SERVICE BULLETIN

#0022

SUBJECT: Replacement of improperly de-embrittled bolts

Figure 1: Sling 2 engine mount to engine frame attachment

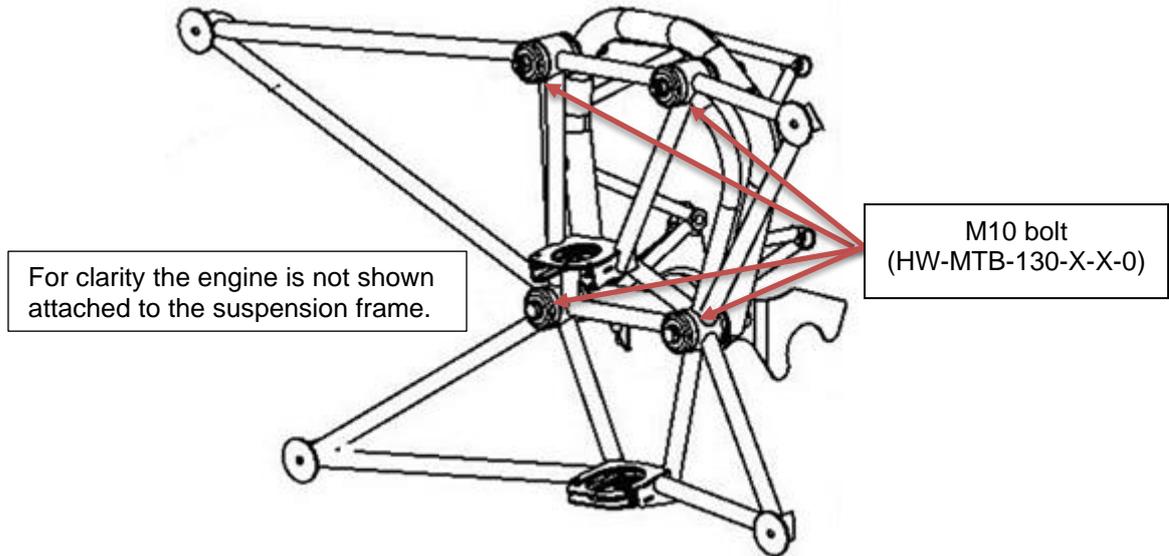
- Step 1: Before any bolts can be replaced, the aircraft's cowling needs to be removed. To do so, refer to the Sling 2 & Sling LSA Maintenance manual (DC-MAM-002-X-B) Section 5.1.1.
- Step 2: The four M10 bolts (HW-MTB-130-X-X-0) that mount the engine to the engine frame need to be replaced. These bolts can be seen in the exploded view of the engine mount in Figure 1.

It is possible to replace the M10 bolts one at a time, without uninstalling the engine.

Figure 2: Rotax 912 iS engine anchor points

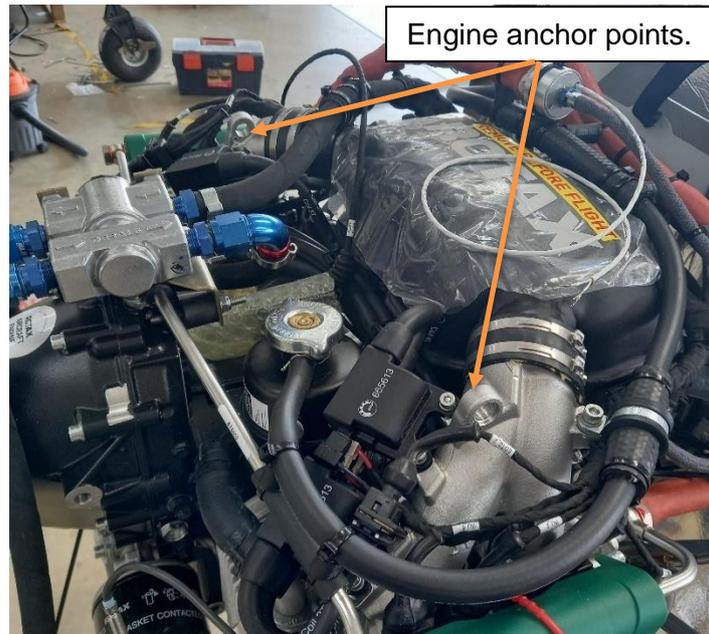
- Step 3: Before any bolts are removed, the engine must be supported. This is to prevent the engine from getting damaged should it drop during the bolt removal, as well as to relieve some strain on the bolts for easy removal. The engine can be supported by the anchor points located on the top of the engine, as shown in Figure 2.

Figure 3: Bolt replacement sequence

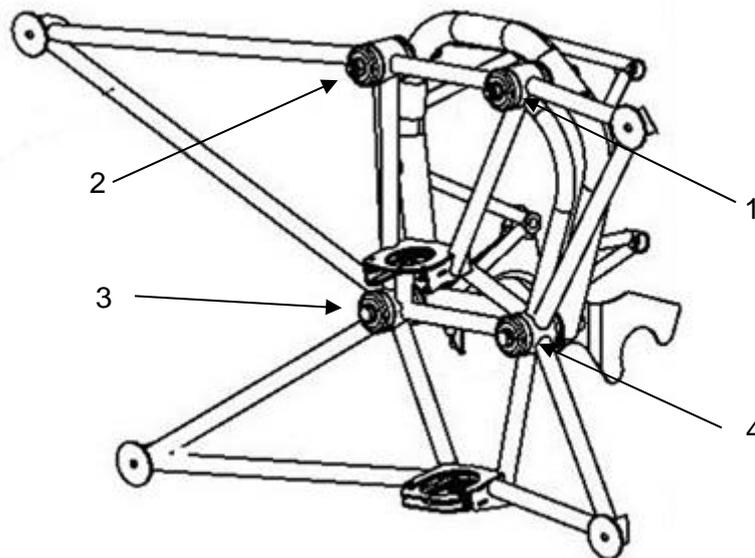
Step 4: Once the engine is supported, the bolts can be replaced *one by one*. Refer to Figure 3 and replace the bolts in order. Remove bolt 1 and install a new bolt. Torque the bolt to 38 Nm. Ensure all washers, rubber stoppers and spacers are installed in the correct positions when replacing the bolts. Once bolt 1 has been replaced and torqued to 38 Nm, replace bolt 2, which should then also be torqued to 38 Nm.

Figure 4: Detaching of the Rotax 912 iS exhaust.

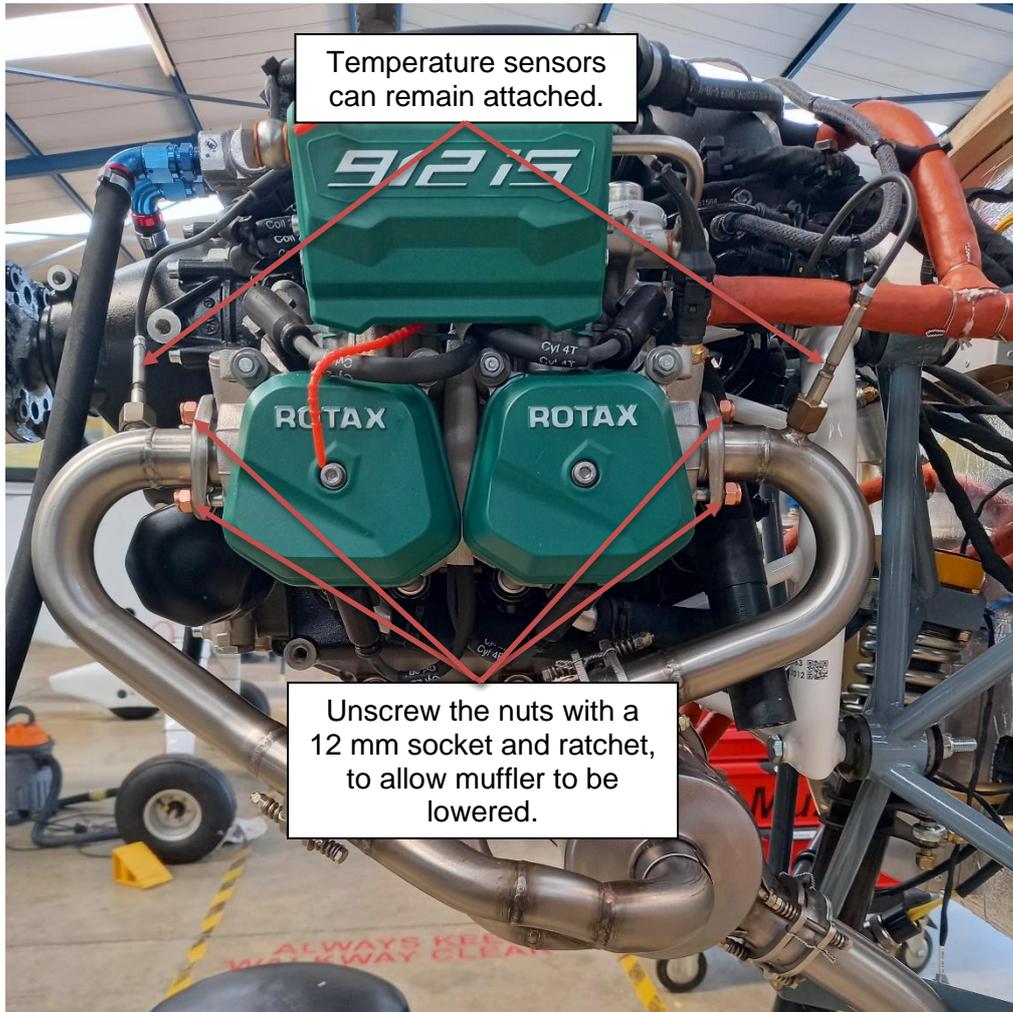
Step 5: Before bolts 3 and 4 can be replaced the muffler needs to be lowered, to create enough clearance to remove the bolts. As shown in Figure 4, the nuts holding the exhaust pipes to the engine should be unscrewed to allow the pipes to detach from the engine. Do not detach the exhaust tubes from the muffler. This must be done for both the left- and right-hand side of the engine so that the exhaust can detach on both sides of the aircraft. The

two temperature sensors on each exhaust pipe can remain attached as there should be sufficient play in the wire length to lower the muffler enough to remove the bolts.

Figure 5: Sling 2 muffler ring clamps

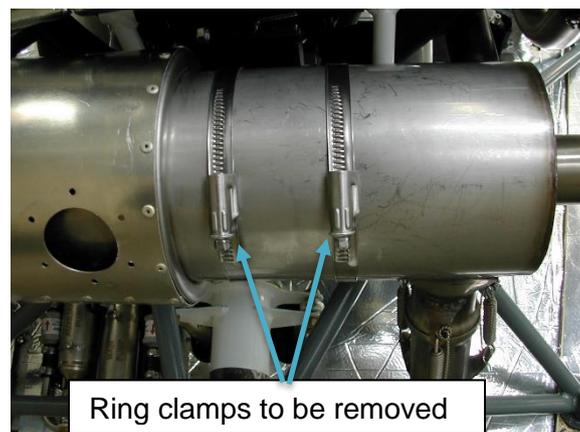
Step 6: There are two ring clamps that restrain the muffler. Before it can be lowered, these ring clamps must be removed.

Figure 6: M8 bolts connecting the propeller extension and engine flange

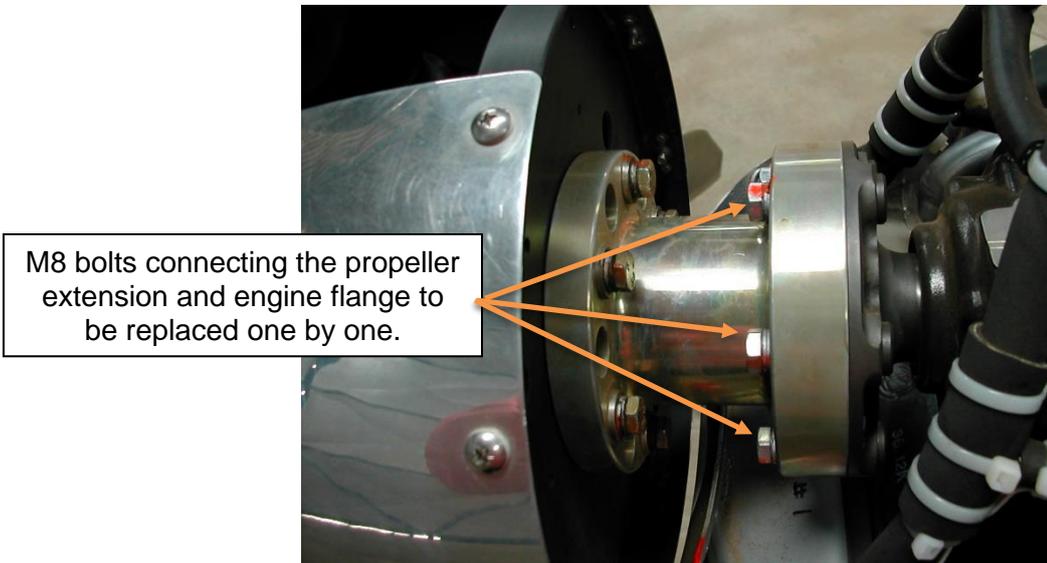
- Step 1: Before any bolts can be replaced, the aircraft's cowling needs to be removed. To do so, refer to the Sling 2 & Sling LSA Maintenance Manual (DC-MAM-002-X-B) Section 5.1.1.
- Step 2: It is possible to replace the M8 bolts (HW-MTB-840-X-X-0) without removing the propeller.
- Step 3: The bolts that need to be replaced are the M8 bolts connecting the propeller extension and engine flange. Refer to Figure 6.

Figure 7: Propeller extension bolt replacement sequence

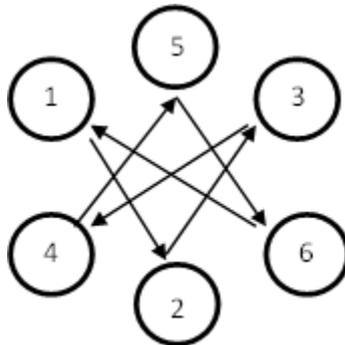
- Step 4: Support the propeller and replace the M8 bolts one by one. This will allow the propeller to remain attached during the replacement process. The bolts should be replaced in accordance with the sequence shown in Figure 7. Loctite 243 should be applied to the threaded section of each replacement bolt before it is installed. Ensure that only one bolt is replaced at a time, and it gets torqued to the correct torque value of 24 Nm, before the next bolt is replaced.

Figure 8: Sling 4 TSi engine mount to engine frame attachment

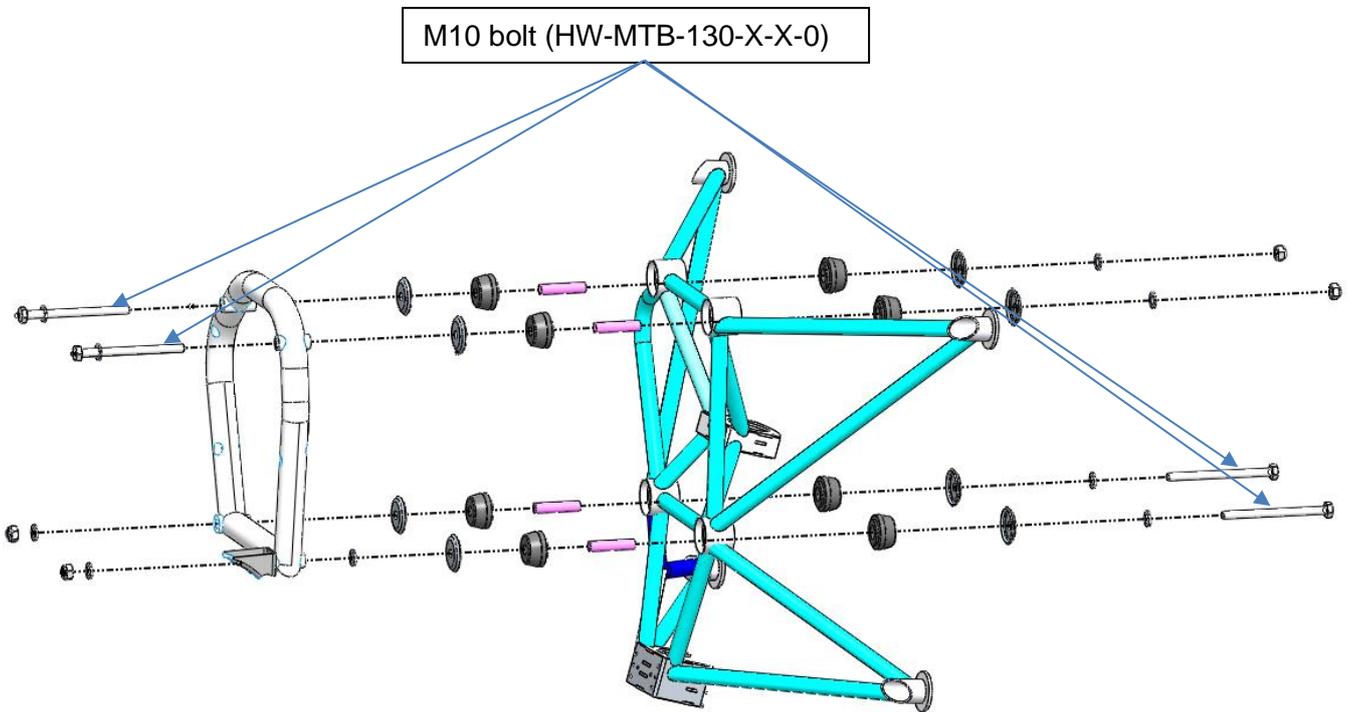
- Step 1: Before any bolts can be replaced, the aircraft's cowling needs to be removed. To do so, refer to the Sling 4 TSi Maintenance Manual (DC-MAM-001-X-F) Section 5.1.1.
- Step 2: The four M10 bolts (HW-MTB-130-X-X-0) that mount the engine to the engine frame need to be replaced. These bolts can be seen in the exploded view of the engine mount in Figure 8.

It is possible to replace the M10 bolts one at a time, without uninstalling the engine.

Figure 9: Rotax 915 iS engine anchor points

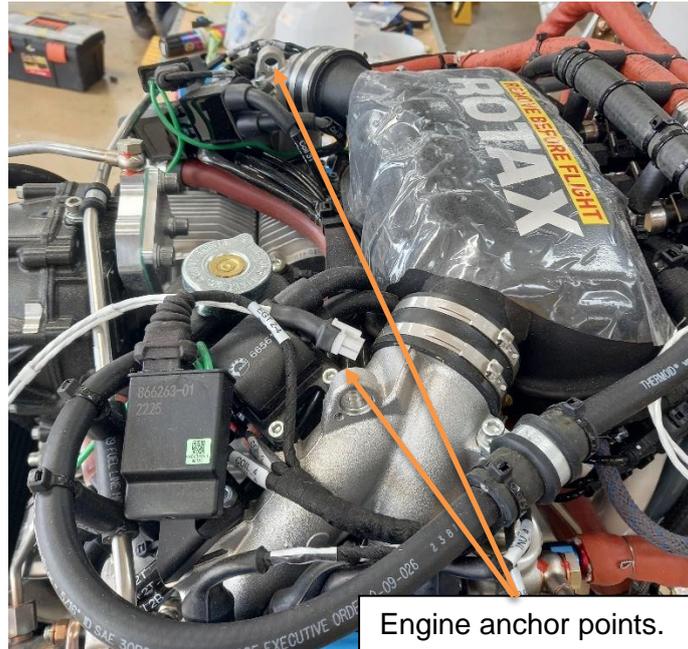
- Step 3: Before any bolts are removed the engine must be supported. This is to prevent the engine from getting damaged should it drop during the bolt removal, as well as to relieve some strain on the bolts for easy removal. The engine can be supported by the anchor points located on the top of the engine, as shown in Figure 9.

Figure 10: Bolt replacement sequence

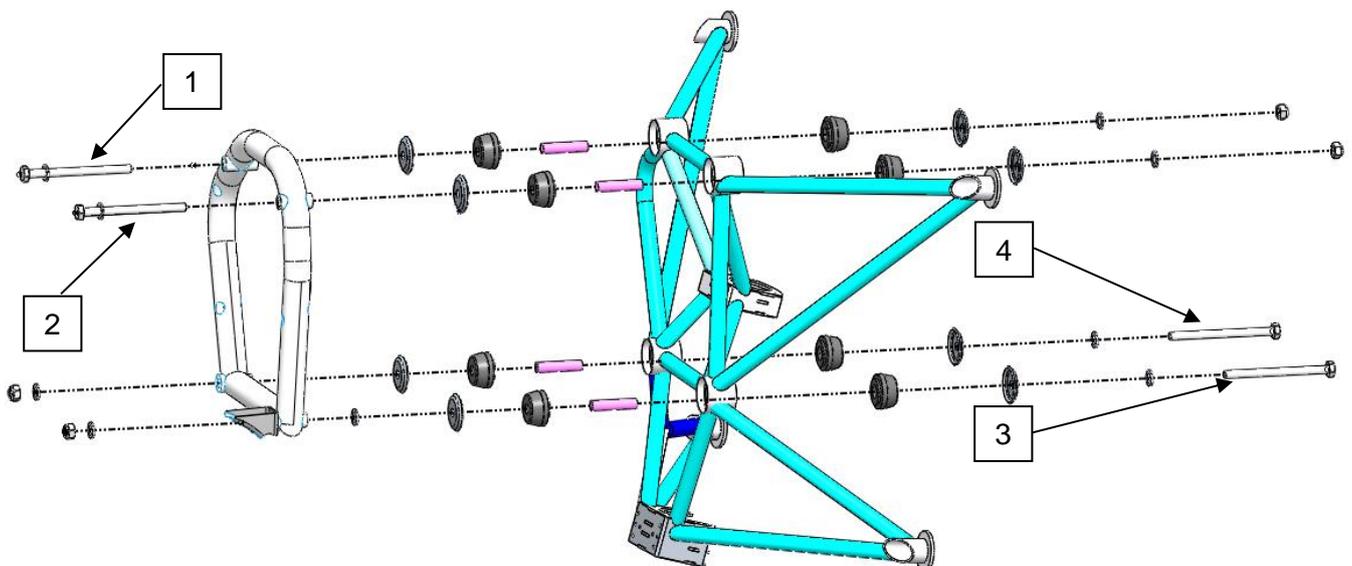
Step 4: Once the engine is supported, the bolts can be replaced *one by one*. Refer to Figure 10 and replace the bolts in order. Remove bolt 1 and install the new replacement bolt. Torque the bolt to 38 Nm. Once bolt 1 has been replaced and torqued to 38 Nm, replace bolt 2. Repeat this process until all 4 bolts have been replaced. All bolts should be torqued to 38 Nm. Ensure all washers, rubber stoppers and spacers are installed in the correct positions when replacing the bolts, as seen in Figure 10. The muffler of the Sling 4 TSi does not need to be lowered in order to replace the M 10 bolts shown in Figure 10.
